# Access Compliance Report

## Public Rights-of-Way

### (Curb Ramps)

Intersection ID: 11693	Main Street: E_12TH_ST	Cross Street: N_COLLEGE_ST	Location: S
ADA ID: 9C2769C50B24	Ramp Type: Directional1	Initial Pass/Fail: Fail	Overall Compliance: No
Severity Score: 58.75			
Codes/Mitigation Info/Possible Solution		Field Measurements/Component Compliance

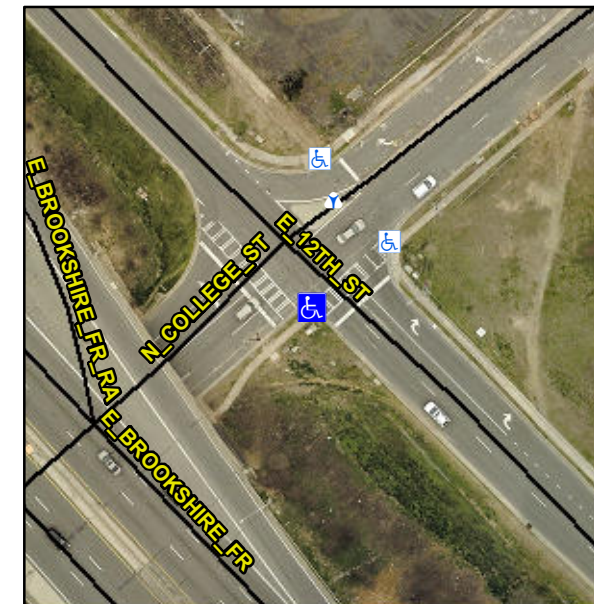
**R304.5.1, R304.2.2, R304.5.3**

Compliance	Description	Data	Compliance	Description	Data
N/A	Ramp Length (in)	47.0	N/A	Grade Break?	N/A
No	Ramp Width (in)	45.0	N/A	Grade Break Slope (%)	0.0
No	Ramp Slope (%)	15.1	N/A	Grade Break XSlope (%)	0.0
No	Ramp XSlope (%)	8.0			
N/A	Flare Type LT	N/A	N/A	Flare Type RT	N/A
N/A	Flare Slope LT (%)	N/A	N/A	Flare Slope RT (%)	0.0
N/A	Flare Traversable LT?	N/A	N/A	Flare Traversable RT?	N/A
N/A	Landing Length (in)	0.0	N/A	DWS Provided?	N/A
N/A	Landing Width (in)	0.0	N/A	DWS Contrast?	N/A
N/A	Landing Slope (%)	0.0	N/A	DWS Length (in)	N/A
N/A	Landing X Slope (%)	0.0	N/A	DWS Full Width?	N/A
N/A	Landing Curb? (Y/N)	N/A	N/A	DWS Offset LT (in)	N/A
N/A	Shared Landing?	N/A	N/A	DWS Offset RT (in)	N/A
N/A	Gutter Ponding?	0.0	N/A	Gutter Slope (%)	N/A
N/A	Gutter Lip Ht (in)	2.0	N/A	Gutter X Slope (%)	N/A
N/A	Painted X Walk1?	Yes		Road Slope (%)	0.5
	X Walk 1 Direction	To NE		Road X Slope (%)	10.4
	X Walk 1 Width (in)	105.0		Clear Space?	N/A

X Walk 1 Slope (%)	0.5	N/A	Clear Space to XWalk (in)	N/A
	X Walk 1 X Slope (%)	10.4	N/A	Storm Grate/Utility Hazard?	N/A
N/A	Ramp inside XWalk1?	Yes		Storm Grate/Utility Type	
N/A	Any Obstructions?	N/A			N/A
	Obstruction Type		Yes	Surface Condition? (G/P)	Good
			N/A	Curb Slope (%)	15.4

**Remove & Replace Entire Ramp.**
